# Work Order ID 89853

Item Name: Crosstube Turning Detail

<b>DART AEROSPACE LTD</b>	<b>Work Order:</b>	89833
<b>Description:</b> Crosstube Assembly (205/212 Low Aft)	<b>Part Number:</b>	D212-664-247
<b>Inspection Dwg:</b> D212-664-247 <b>Rev:</b> B		<b>Page 1 of 2</b>

DRAWING NO. D212-664-247	TITLE CROSSTUBE ASS'Y (205 LOW AFT)	REV. B	DART AEROSPACE LTD ENGINEERING ORDER		D.E.O. NO. D212-664-247-B-1	SHEET NO. SHEET 1 OF 1	SCALE NTS
DRAWN 97	CHECKED ASS	MFG. APPR. JBS	APPROVED WD		DE APPR. JH		
DATE 11.07.15	DATE 11.07.20	DATE 11.07.21	DATE 11/07/21		DATE 11.07.21

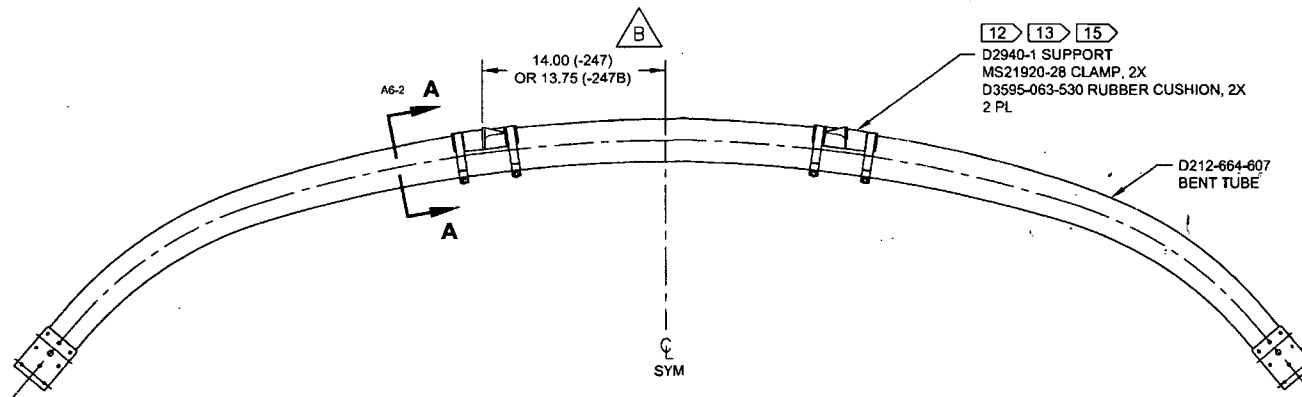
REPLACE MAGNOBOND WITH PROSEAL

NOTE 12 & 15, SHEET 1 IS AMENDED AS FOLLOWS:

- 12) INSTALL D2940-1 SUPPORT USING 0.03" TO 0.06" THICK LAYER OF MAGNOBOND 6398 TO THE SURFACE OF D2940-1 THAT WILL BE IN CONTACT WITH THE CROSSTUBE PER QSI 015. LET CURE FOR 12 HOURS AFTER INSTALLATION AND PRIOR TO PACKAGING.
- 15) TORQUE CLAMPS 80 TO 100 IN-LB. ENSURE AT LEAST 1.5 THREADS SHOWING IN SAFETY AND THAT NUT HAS NOT BOTTOMED-OUT AFTER TORQUING.

- 12) TO INSTALL D2940-1 SUPPORT: ABRASE MATING SURFACE OF SUPPORT AND CROSSTUBE WITH 180-GRIT SANDPAPER AND REMOVE RESIDUE WITH MEK (OR EQUIVALENT). APPLY A 0.04" TO 0.07" THICK LAYER OF PROSEAL 890 CLASS B-2 (OR AMS-S-8802 CLASS B-2) SEALANT TO MATING SURFACE OF SUPPORT.
- 15) TORQUE CLAMPS 80 TO 100 IN-LB. ENSURE AT LEAST 1.5 THREADS SHOWING IN SAFETY AND THAT NUT HAS NOT BOTTOMED-OUT AFTER TORQUING. **PRIOR TO PACKAGING, RE-CHECK TORQUE ON CLAMPS AFTER PROSEAL 890 SEALANT HAS CURED FOR 72 HOURS.**

**D212-664-247TRN  
TURNING DETAIL**

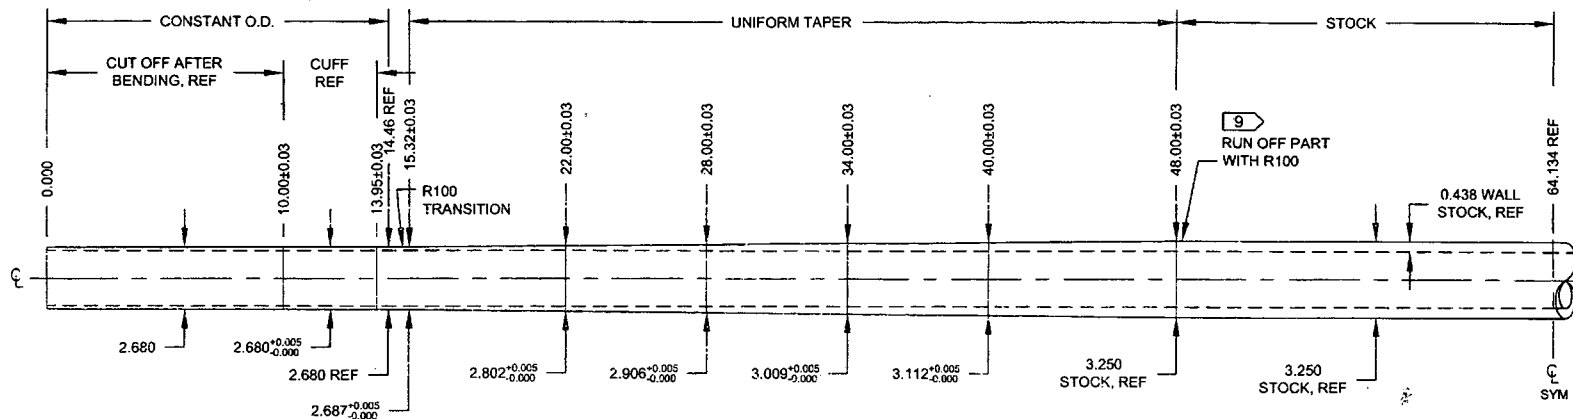
Root Cause		Date	Step	Qty	Description of work order update or Non-conformance	Initial Chief Eng	Action Description	Sign & Date	Verification	QC Inspector
Doc/Data		12/9/24	100	1	Crosstube is over tolerance throughout Entire length.	 12/9/24	Max of 0.002" over tol. in some locations.  Acceptable	 12/9/24	JW  12-9-24	 12/10/01
Equip/Tooling										
Operator										
Material										
Setup										
Other										
Process										
Supplier										
Training										
Unapproved
